REPORT OF SERVICE TEST PHASE OF
USATECOM PROJECT NO 8-3-4410-03 D,
INTEGRATED ENGINEERING/SERVICE TEST OF
ENTAC ATGM WITH MOUNTING KIT FOR
M151, 1/4-TON TRUCK (U)
DECEMBER 1963

SUBJECT: Reports on USATECOM Project Nos. 8-3-4410-01, -03, -05 and -08,
Engineering-Service Test of ENTAC Antitank Guided Missile with
Mounting Kit for M151, $\frac{1}{2}$ Ton Truck (U)

REPORT OF SERVICE TEST PHASE OF
USATECOM PROJECT NO 8-3-4410-03 D,
INTEGRATED ENGINEERING/SERVICE TEST OF
ENTAC ATGM WITH MOUNTING KIT FOR M151, 1/4-TON TRUCK (U)
1 July 1963 - 16 October 1963

Results of driving Test System 20 miles over Dust Course at YTS.

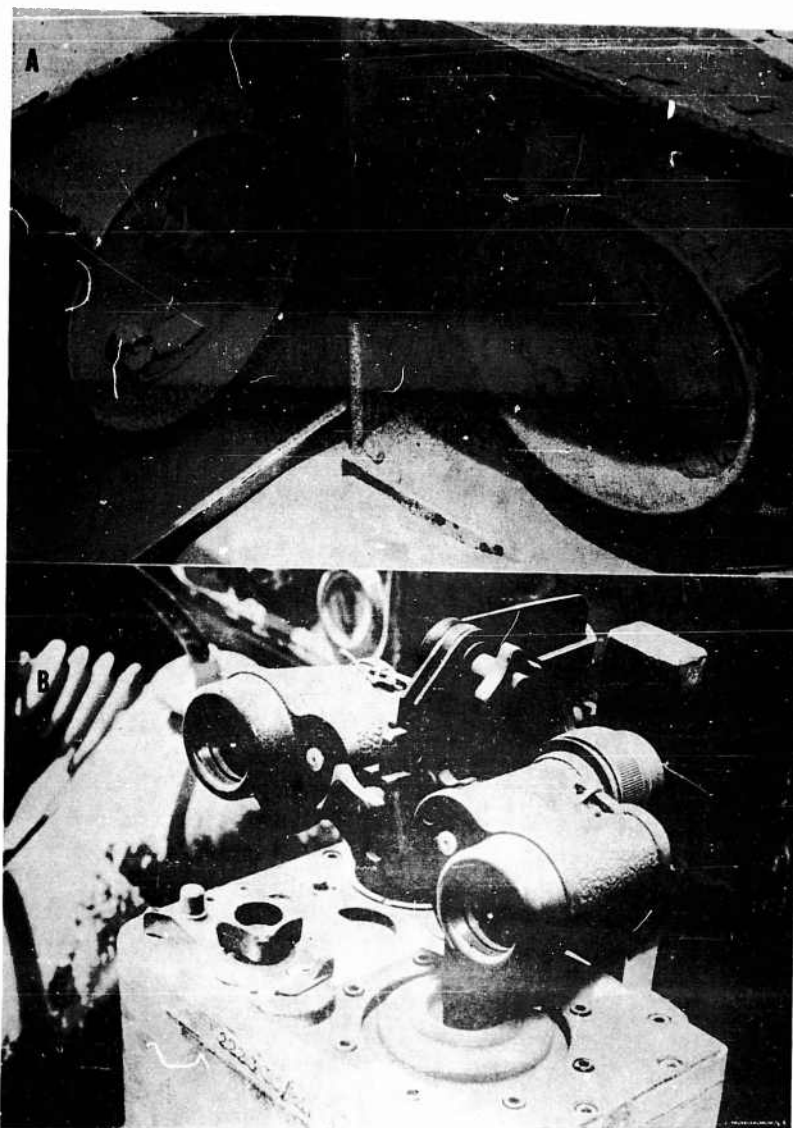
d. The failure of the test kit to provide an adequate means of protecting the on-vehicle missiles from dust or weather is a shortcoming.

8. The test kit failed to provide an adequate means of protecting the on-vehicle missiles from dust or weather.

- A. Plexiglass Shield.
- B. Improvised Shield.

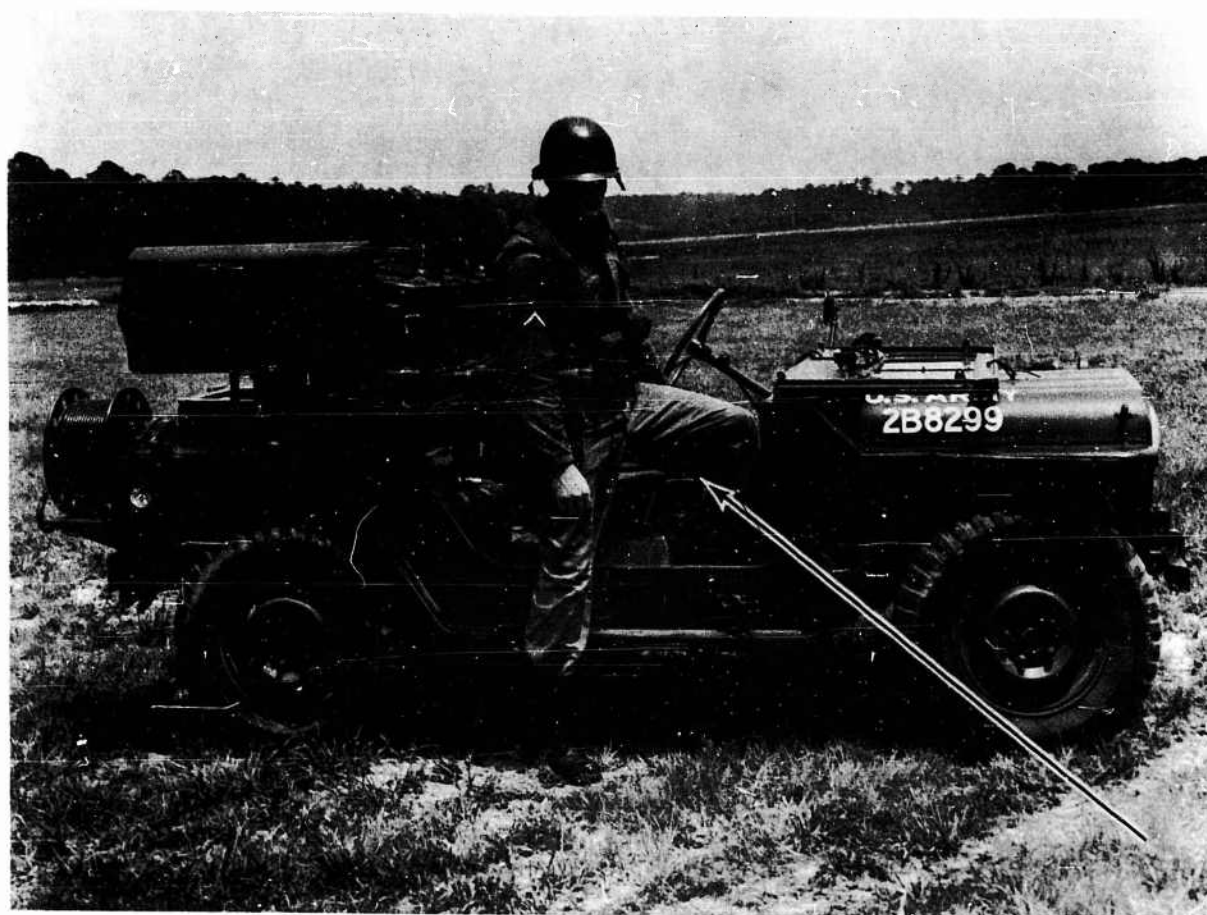
(3) The lenses of the binoculars had to be washed after firing on-vehicle missiles to remove the electrolyte that had sprayed on them.

1. The plexiglass shield did not afford adequate protection to the gunner's eyes from the electrolyte sprayed to the rear when a missile was launched.
2. The test kit did not provide a means of preventing the gunner from injuring himself on the exposed pintle on the gunner's seat when mounting or dismounting the vehicle and when riding over rough terrain.
3. The Launching Container Securing Latches failed to readily secure 11 out of 62 Launching Containers to the Launching Platform.
4. The Elevating Mechanism failed to operate properly because of the accumulation of dust and grit in the gears after cross-country operation of the vehicle.

Arrow Indicates Guidance and Control Unit Mounting Pintle.

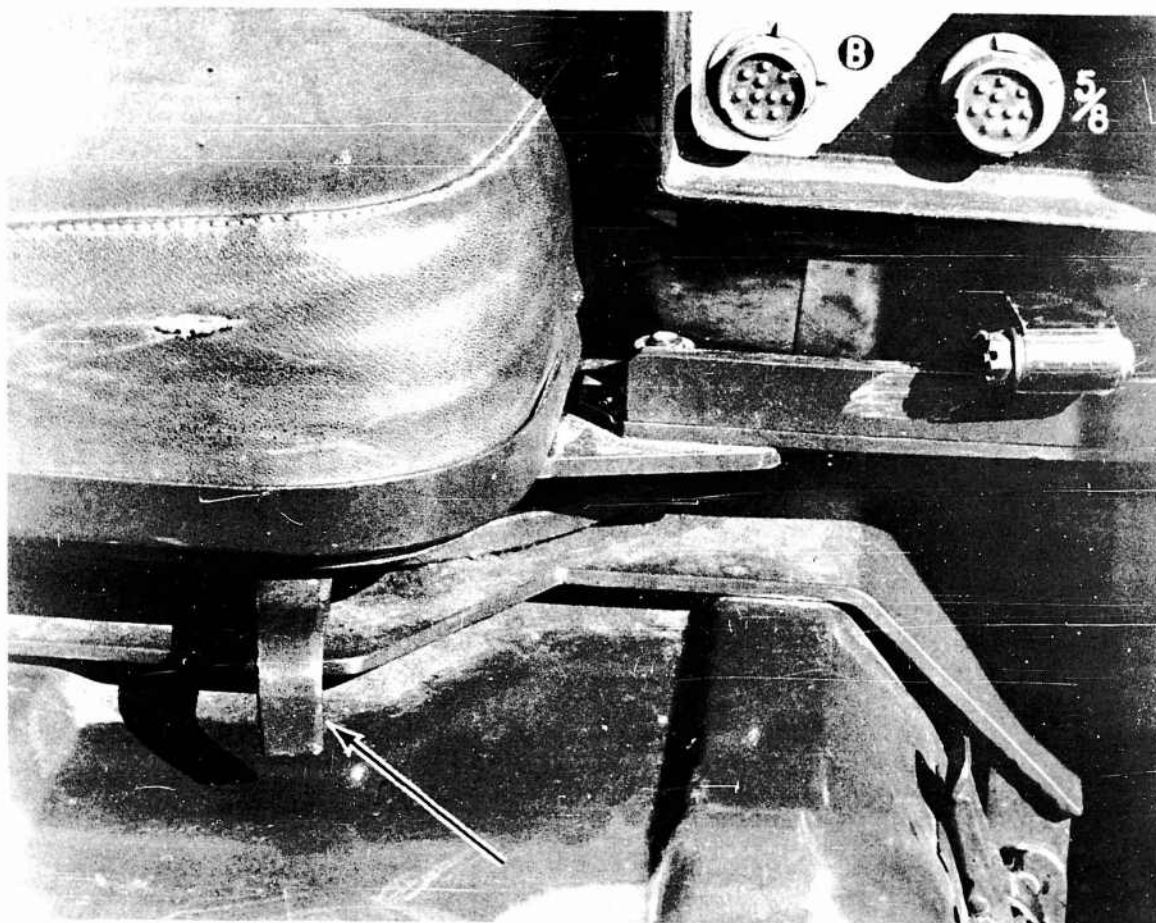
a. The failure of the test kit to provide a means of preventing the gunner from injuring himself on the exposed pintle on the gunner's seat when mounting or dismounting the vehicle or when riding over rough terrain is a deficiency.

Provide an easily removable, padded cover for the pintle.
